# Access Compliance Report

### (Curb Ramps)

Intersection ID: 21135	Main Street: ALLISON_AV	Cross Street: SHARON_VIEW_RD	Location: NW
ADA ID: 67C850F39D9F	Ramp Type: PerpDiag	Initial Pass/Fail: Fail	Overall Compliance: No
Severity Score: 8.75			
Codes/Mitigation Info/Possible Solution		Field Measurements/Component Compliance

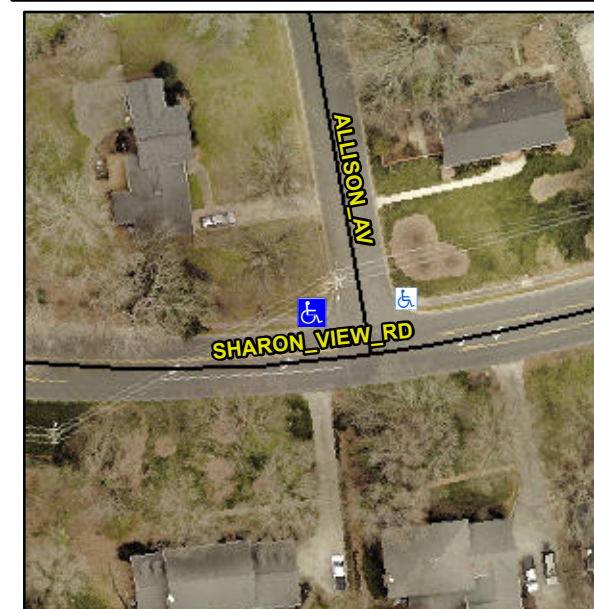
**Not Found, R304.5.1**

Compliance	Description	Data	Compliance	Description	Data
N/A	Ramp Length (in)	23.0	Yes	Ramp Slope (%)	7.5
No	Ramp Width (in)	45.0	Yes	Ramp XSlope (%)	1.2
N/A	Flare Type LT	N/A	N/A	Flare Type RT	N/A
N/A	Flare Slope LT (%)	N/A	N/A	Flare Slope RT (%)	N/A
N/A	Flare Traversable LT?	N/A	N/A	Flare Traversable RT?	N/A
N/A	Landing Length (in)	N/A	N/A	DWS Provided?	N/A
N/A	Landing Width (in)	N/A	N/A	DWS Contrast?	N/A
N/A	Landing Slope (%)	N/A	N/A	DWS Length (in)	N/A
N/A	Landing X Slope (%)	N/A	N/A	DWS Full Width?	N/A
N/A	Landing Curb? (Y/N)	N/A	N/A	DWS Offset (in)	N/A
N/A	Shared Landing?	N/A			
N/A	Gutter Ponding?	N/A	N/A	Gutter Slope (%)	N/A
N/A	Gutter Lip Ht (in)	N/A	N/A	Gutter X Slope (%)	N/A
N/A	Painted X Walk1?	No	N/A	Painted X Walk2?	No
	X Walk 1 Direction	To S		X Walk 2 Direction	To E
N/A	X Walk 1 Width (in)	N/A	N/A	X Walk 2 Width (in)	N/A
	X Walk 1 Slope (%)	5.9		X Walk 2 Slope (%)	5.0
	X Walk 1 X Slope (%)	4.3		X Walk 2 X Slope (%)	3.7

**Remove & Replace Curb Ramp With Two New Directional Ramps or Equivalent.**
